Access Compliance Report

Public Rights-of-Way

Intersection ID: 14941	Main Street: BENJAMIN_ST	Cross Street: S_TRYON_ST	Location:	N
ADA ID: 268A9836EBC6	Ramp Type: PerpDiag	Initial Pass/Fail: Fail	Overall Compliance: No	Severity Score: 12.5

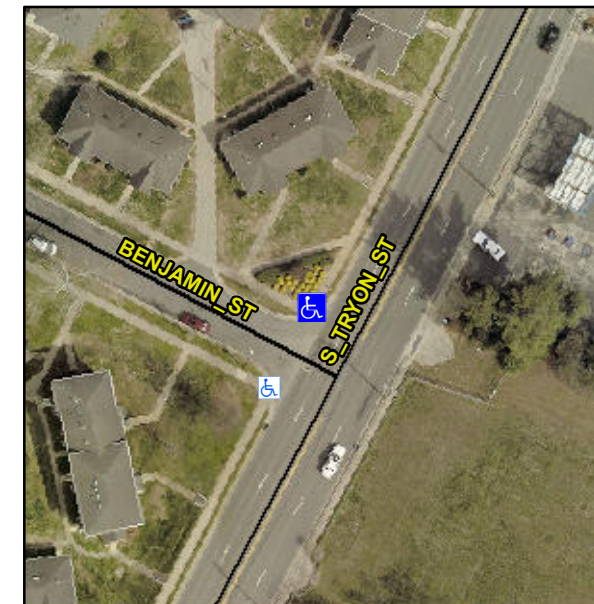
Not Found, R304.2.2

Compliance	Description	Data	Compliance	Description	Data
N/A	Ramp Length (in)	60.0	No	Ramp Slope (%)	10.0
Yes	Ramp Width (in)	48.0	Yes	Ramp XSlope (%)	0.3
N/A	Flare Type LT	N/A	N/A	Flare Type RT	N/A
N/A	Flare Slope LT (%)	N/A	N/A	Flare Slope RT (%)	N/A
N/A	Flare Traversable LT?	N/A	N/A	Flare Traversable RT?	N/A
N/A	Landing Length (in)	N/A	N/A	DWS Provided?	N/A
N/A	Landing Width (in)	N/A	N/A	DWS Contrast?	N/A
N/A	Landing Slope (%)	N/A	N/A	DWS Length (in)	N/A
N/A	Landing X Slope (%)	N/A	N/A	DWS Full Width?	N/A
N/A	Landing Curb? (Y/N)	N/A	N/A	DWS Offset (in)	N/A
N/A	Shared Landing?	N/A			
N/A	Gutter Ponding?	N/A	N/A	Gutter Slope (%)	N/A
N/A	Gutter Lip Ht (in)	N/A	N/A	Gutter X Slope (%)	N/A
N/A	Painted X Walk1?	No	N/A	Painted X Walk2?	No
	X Walk 1 Direction	To SW		X Walk 2 Direction	To SE
N/A	X Walk 1 Width (in)	N/A	N/A	X Walk 2 Width (in)	N/A
	X Walk 1 Slope (%)	2.6		X Walk 2 Slope (%)	1.6
	X Walk 1 X Slope (%)	1.9		X Walk 2 X Slope (%)	3.4

Remove & Replace Curb Ramp With Two New Directional Ramps or Equivalent.
